STAFF RECOMMENDATION
1111 Lillian Street
May 17, 2017

Application: New construction – infill with setback determination

District: Lockeland Springs-East End Neighborhood Conservation Zoning Overlay

Description of Project: The applicant is proposing to construct a new one and one-half story dwelling on the lot.

EAST ELEVATION

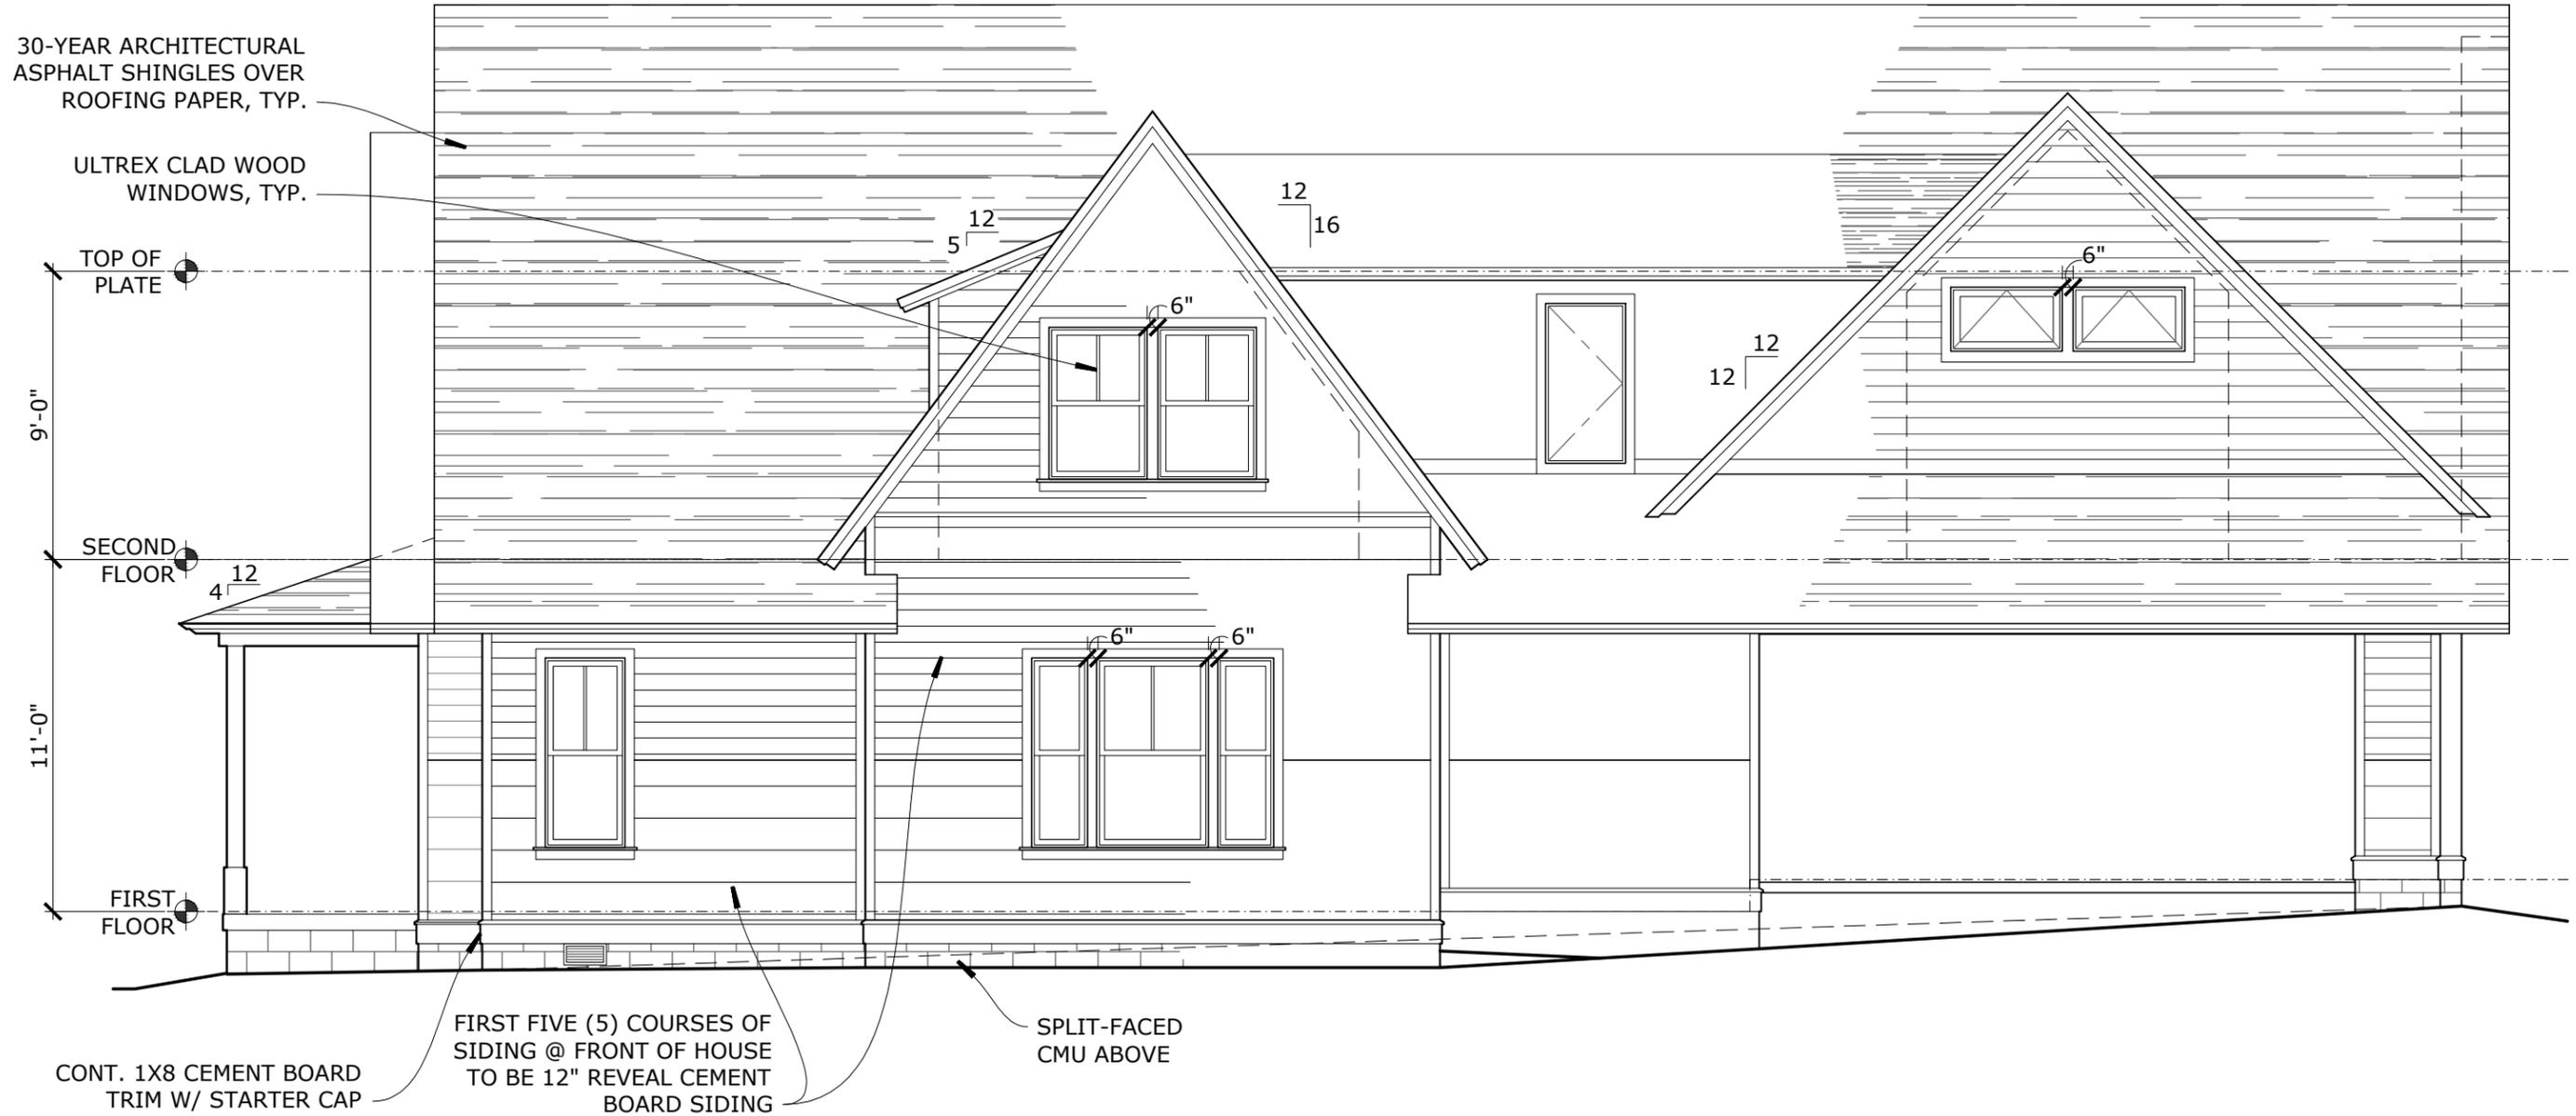
Rhythm and Proportion of Openings: The windows on the house will be generally twice as tall as they are wide, and the first story windows will be taller than those on the upperstory, as seen historically. The windows have six inch (6”) mullions between, also

as seen historically. There will be no expanse greater than ten feet (10') without an opening on any of the primary elevations. The rear cross gable has horizontal windows which are not typical of the proportion of historic openings; however, staff finds them to be appropriate since they will be minimally visible. Staff finds that the proposal will meet guideline II.B.7.
